Access Compliance Report Public Rights-of-Way (Curb Ramps)

Main Street: HAMER_DR Cross Street: TABAH_LN Location: SW

ADA ID: RPRK210917154648 Ramp Type: Type 1 - Perpendicular Diagonal Initial Pass/Fail: Pass Overall Compliance: No Severity Score: 6

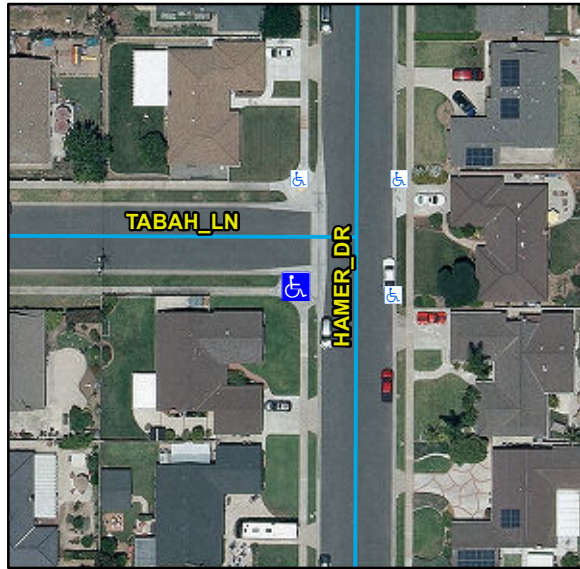
R304.2.2, R304.2.1, R302.7, STD 1115

Remove & Replace Curb Ramp With Two New Directional Ramps or Equivalent.
